## **ADDENDUM NUMBER TWO**

PROJECT NO. 10238.00/6.6

**A NEW WORSHIP FACILITY**

**TABERNACLE BAPTIST CHURCH  
Selma, Alabama**

FIRST FLOOR  
DIMENSION AND  
REFERENCE PLAN  
**A2.1**  
Project number 10238.00  
Date 05/20/2022  
1/27/2022 3:16:56 PM

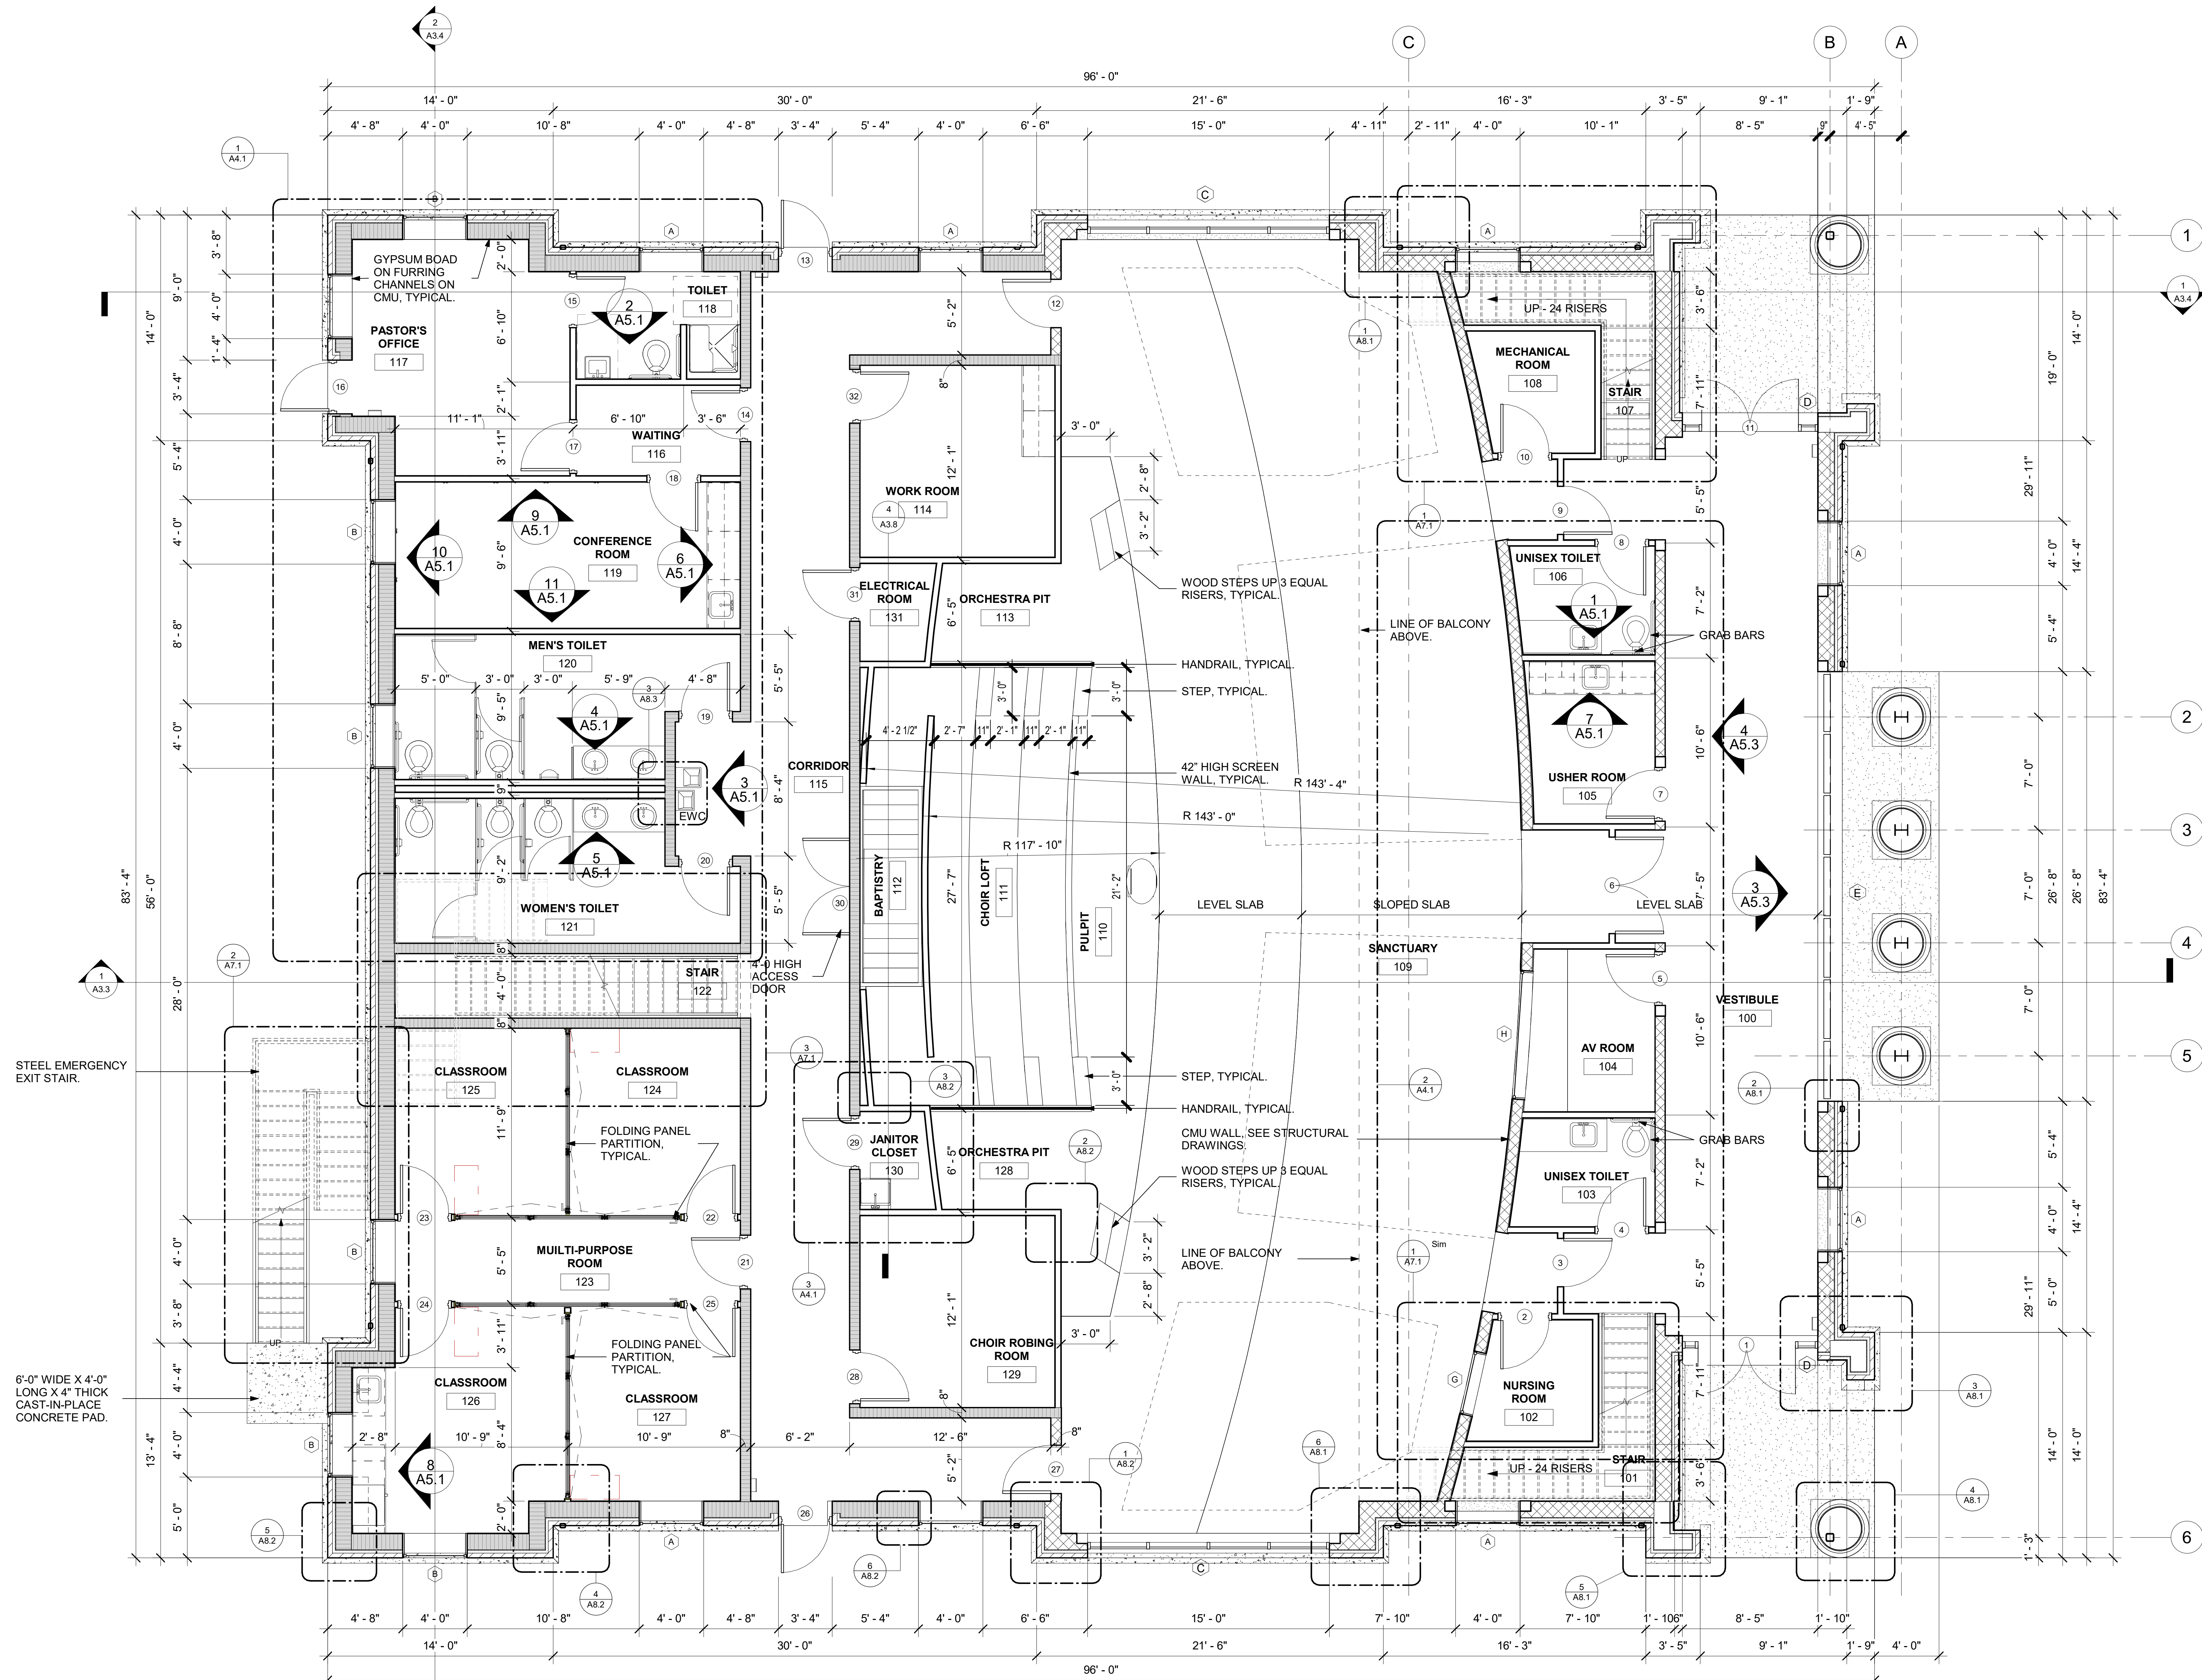
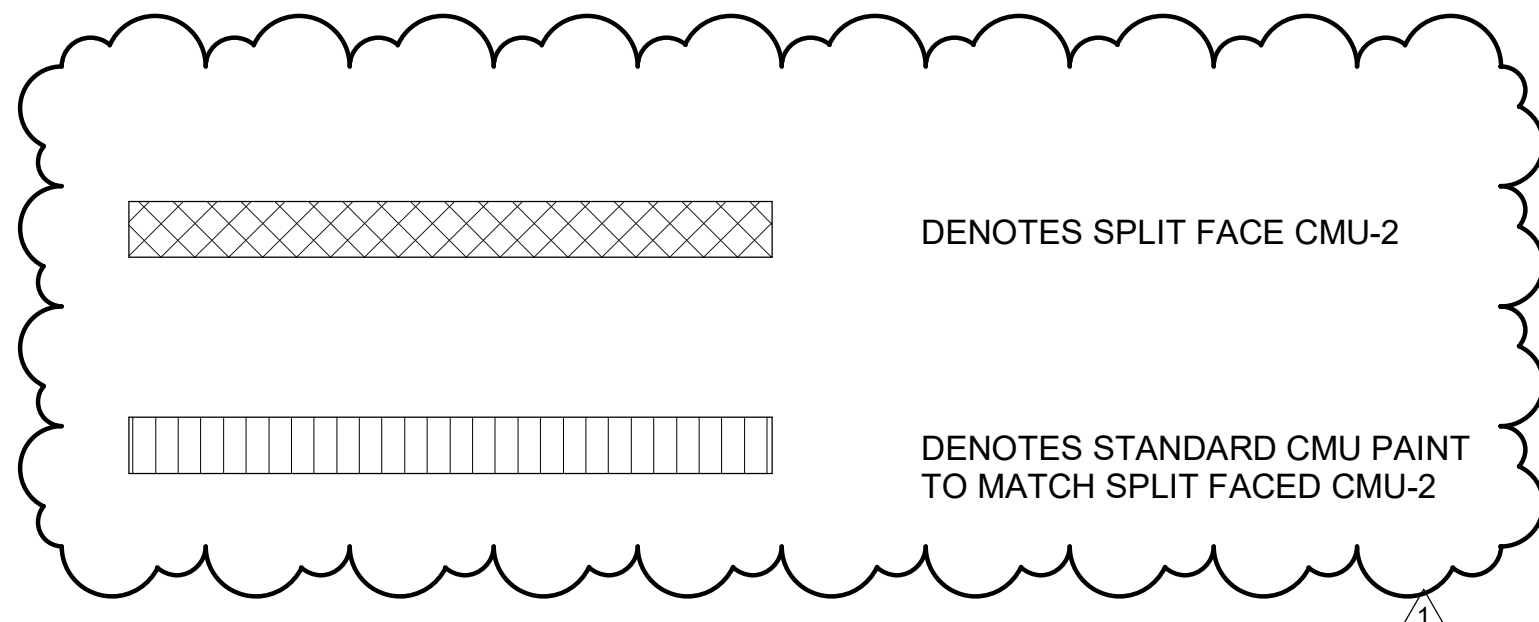
1. ON DRAWING SHEETS A2.1 – A2.2, the following clarification is offered:
  - a. A legend has been added to the drawing sheet that denotes the extent of the Split Faced CMU-2 and the standard CMU used in the construction of the interior and exterior CMU walls. See ASD Numbers 1 and 2, attached to this Addendum Two.
2. ON DRAWING SHEETS A3.1- A3.8, the following clarification is offered:
  - a. Where the column covers are shown to be fiberglass, the Contractor shall have the option to provide GFRC Column Covers in accordance with Specification Section 03 49 00 – GLASS FIBER REINFORCED CONCRETE COLUMNS.
3. ON DRAWING SHEET D2.0 – FINISH SCHEDULE, make the following change:
